Project Name: UNIVERSITY OF CALIFORNIA, MERCED
NORTH BOWL PARKING 2

Project No.: 906550

ADDENDUM NO. 1
to the
CONTRACT DOCUMENTS
April 22, 2016

C2.1

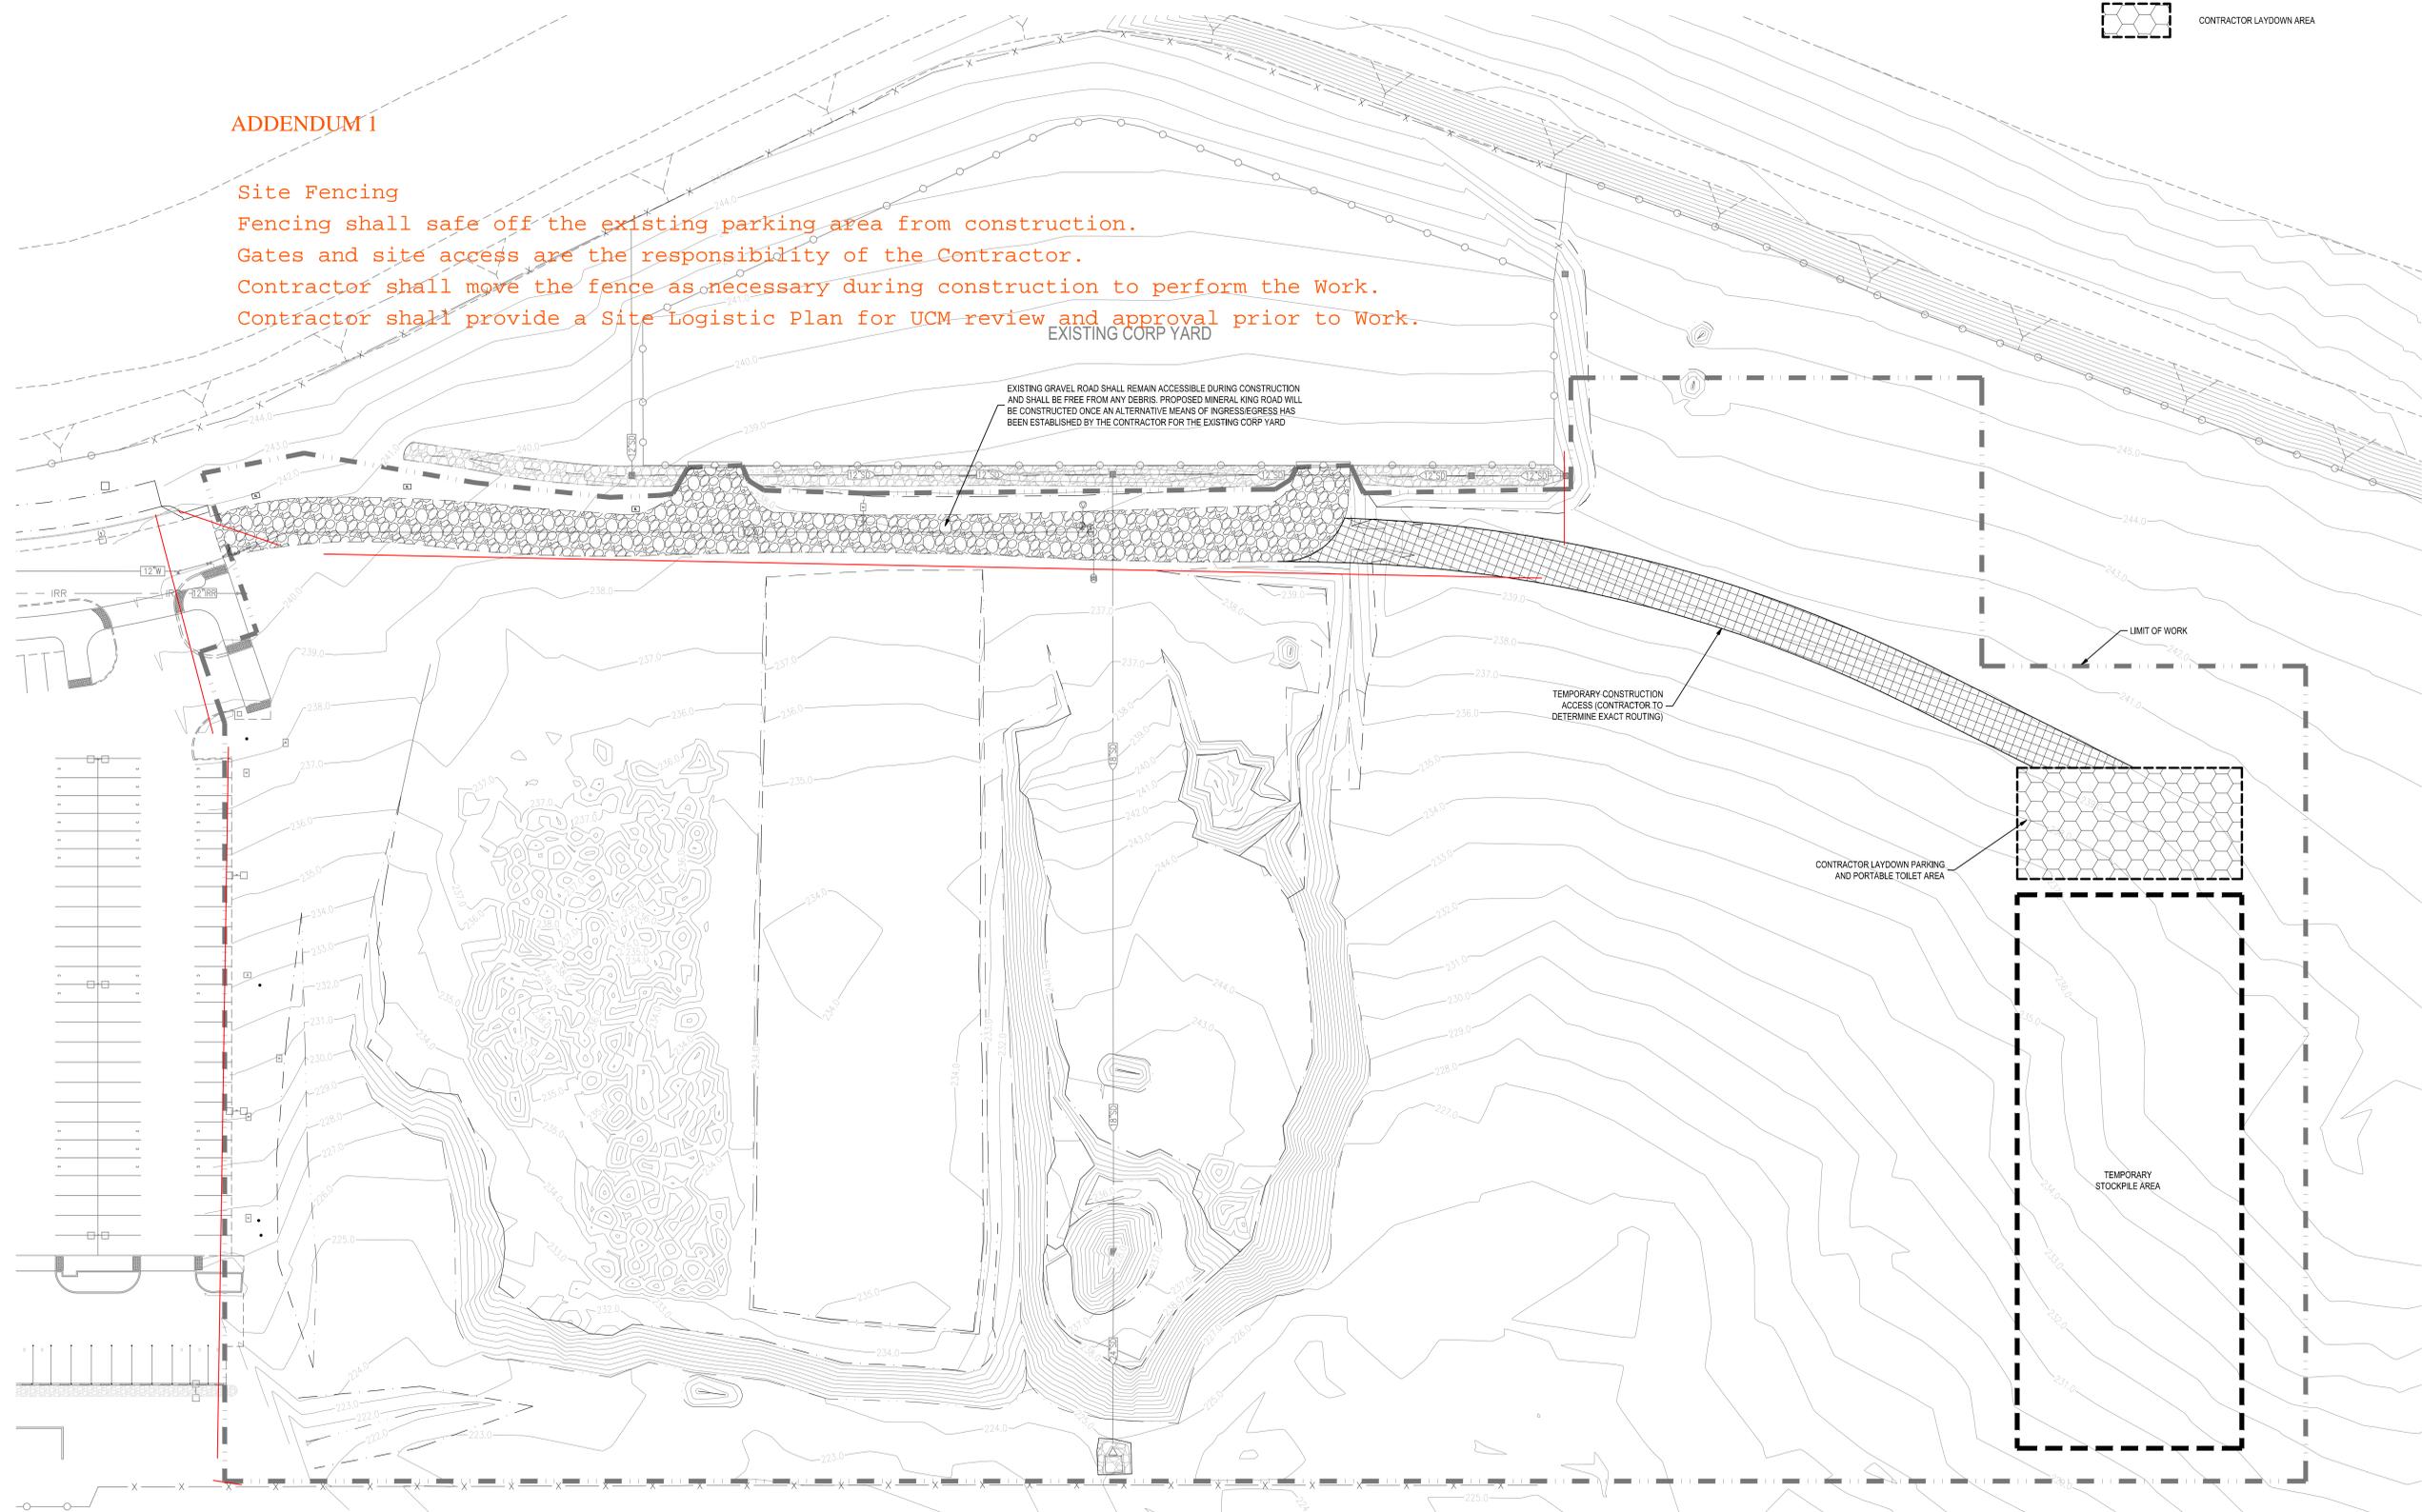
2. Q. Is type of fly ash a Class F?
 - A. Per Specification Section 03 32 00 2.2B, it shall be Class C.
 3. Q. Is temporary fencing required?
 - A. Provide temporary fencing according to sheet C2.1 attached to this Addendum.

4. Q. If temporary fencing is required, provide location(s).
 - A. Provide temporary fencing according to sheet C2.1 attached to this Addendum.
 5. Q. The subgrade preparation plans/specs have conflicting information 6" or 12"?

9. Q. What is to happen with any excess material?
- A. Any excess material shall be stockpiled in the area indicated on sheet C2.1 as the "temporary stockpile area".

10. Q. Does excess material get stock piled on site?
- A. Any excess material shall be stockpiled in the area indicated on sheet C2.1 as the "temporary stockpile area".

- A. Sheet C4.1 does not exist, ignore the reference.
24. Q. Per note on Sheet C2.1 - Existing gravel road shall remain accessible during construction and shall be kept free from any debris. Proposed Mineral King Road will be constructed once an alternate means of ingress/egress has been established by the Contractor for the existing Corp Yard." Will a base rock section in the new parking lot area provide adequate access to the Corp Yard?

Site Fencing

Fencing shall safe off the existing parking area from construction.
Gates and site access are the responsibility of the Contractor.
Contractor shall move the fence as necessary during construction to perform the Work.
Contractor shall provide a Site Logistic Plan for UCM review and approval prior to Work.

EXISTING GRAVEL ROAD SHALL REMAIN ACCESSIBLE DURING CONSTRUCTION AND SHALL BE FREE FROM ANY DEBRIS. PROPOSED MINERAL KING ROAD WILL BE CONSTRUCTED ONCE AN ALTERNATIVE MEANS OF INGRESS/EGRESS HAS BEEN ESTABLISHED BY THE CONTRACTOR FOR THE EXISTING CORP YARD

TEMPORARY STOCKPILE AREA
